**UNITED STATES OF AMERICA
NUCLEAR REGULATORY COMMISSION**

In the Matter of:)	
)	
EXELON GENERATION COMPANY, LLC)	Docket No. 50-352-LR
)	Docket No. 50-353-LR
(Limerick Generating Station, Units 1 and 2))	
)	November 22, 2011
(License Renewal Application)

**NATURAL RESOURCES DEFENSE COUNCIL
PETITION TO INTERVENE AND
NOTICE OF INTENTION TO PARTICIPATE**

10. Figure 1: A chart of the numbers of Initially-Selected or Phase I, and Final or Phase II SAMA candidates analyzed with respect to License Renewal for U.S. BWRs .

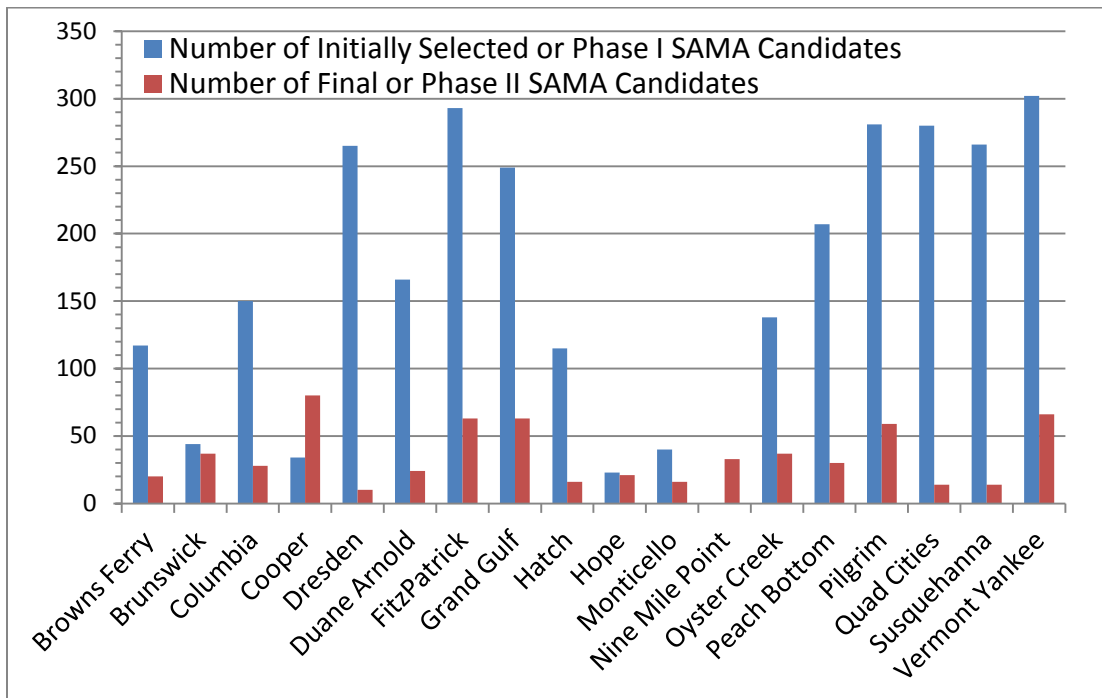
11. (MGM) In my review of these 18 SAMA analyses conducted for BWR License Renewal Applications, the list of initial or Phase I SAMA candidates were developed by applicants both through examining industry documents and by considering plant-specific

enhancements. These industry documents were a product of industry lessons learned covering the time period subsequent to the 1989 Limerick FES, and in addition include SAMA candidates from the Individual Plant Examination (IPE) and Individual Plant Examination of External Events (IPEEE) processes. These resources constitute new and significant information post-dating the Limerick FES Supplement.

38. (MGM) Figure 2: US Bureau of Agriculture data on annual crop sales in the area surrounding Limerick in 2007 (USDA, 2011).

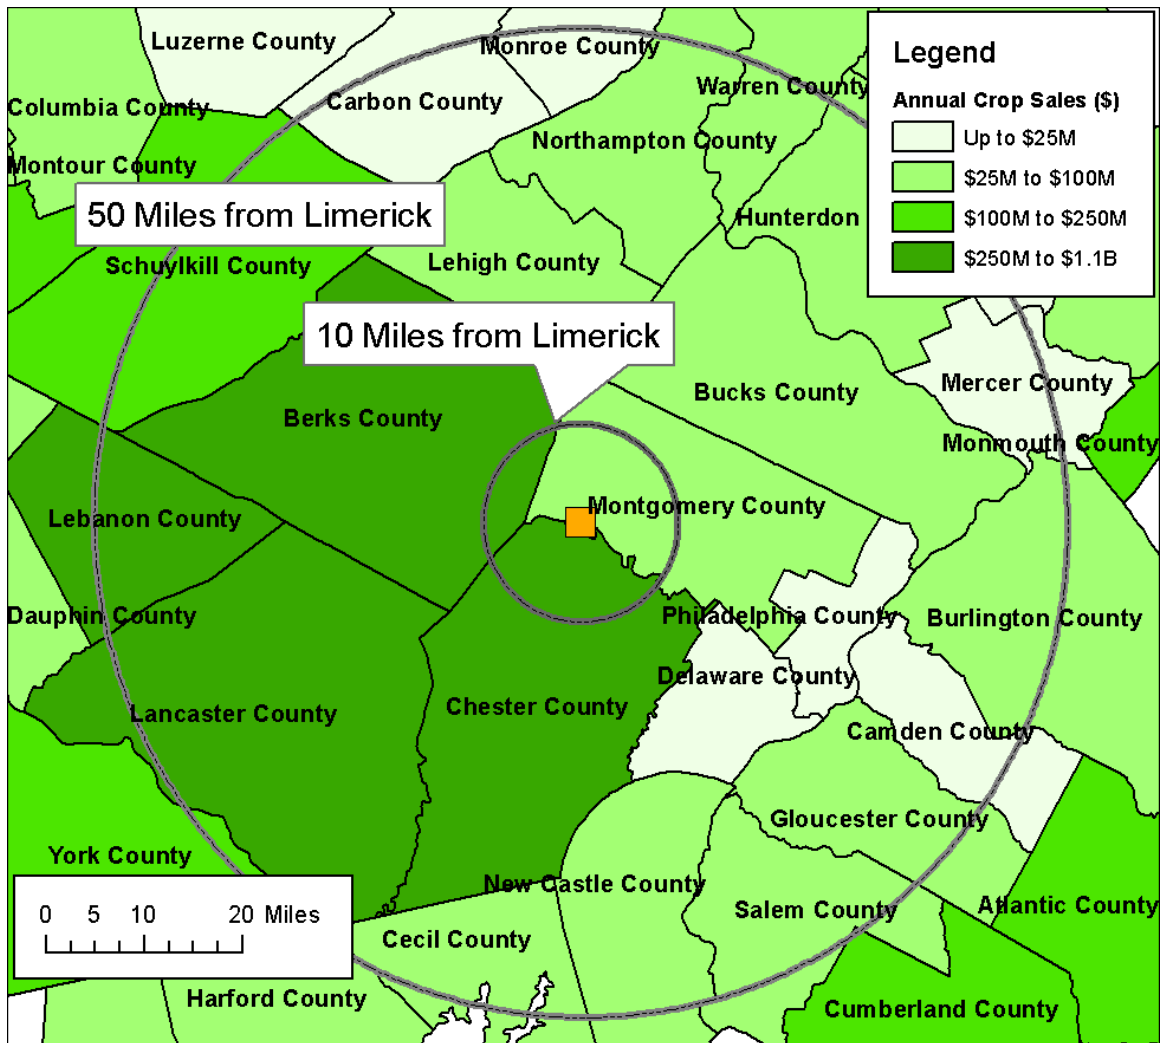
37. (MGM) Agriculture is an important component to the economic risk to the west of Limerick has. As an example of data pertinent to determining economic risk that is absent from the Limerick FES Supplement but found universally in SAMA analyses conducted

for other BWR License Renewal Applications, I have displayed U.S. Bureau of Agriculture statistics on crop sales by county within the 50-mile zone around Limerick in Figure 2 (USDA, 2011). As can be seen in this figure, Lancaster County to the southwest of Limerick had over \$1 billion in crop sales in 2007, Chester Counties had about one-half billion dollars in crop sales in 2007, and Berks County had about \$400 million in crops sales in 2007 (USDA, 2011).

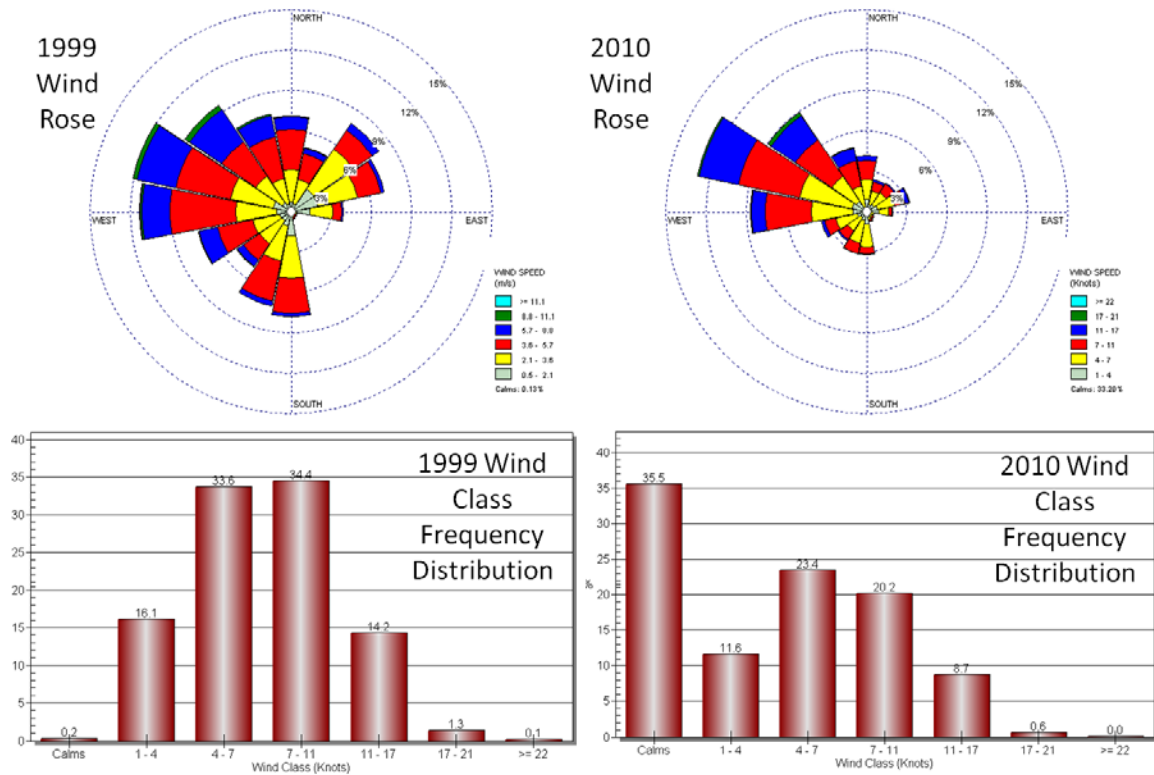
Therefore, perform sensitivity analysis to show that variations in this parameter would not impact the results of the analysis.” (NEI, 2005). The evacuation modeling performed in the 1984 FES appears to overestimate the evacuation speed based on comparisons with SAMA analyses in support of other reactor re-licensing, and does not include an uncertainty analysis.

44. (CJW) Finally, the FES Supplement for Limerick does not contain a sensitivity analysis with regard to evacuation speeds as described in the NRC SAMA guidance document. SAMA analyses for other nuclear power plants have provided the results of a sensitivity analysis, exploring the offsite exposure doses as a percentage change from the base speed result. I find that doses are characteristically determined for a 50% reduction in the evacuation speed, for which the resulting collective dose ranges anywhere from a few percent difference to as much as 15 percent higher. Therefore the sensitivity analysis

performed for SAMA analysis at other nuclear power plants reinforces that a reduction in evacuation speed from an updated SAMA analysis for Limerick could materially alter the assessment of impacts of a severe accident and the cost-benefit results of certain mitigation alternatives.
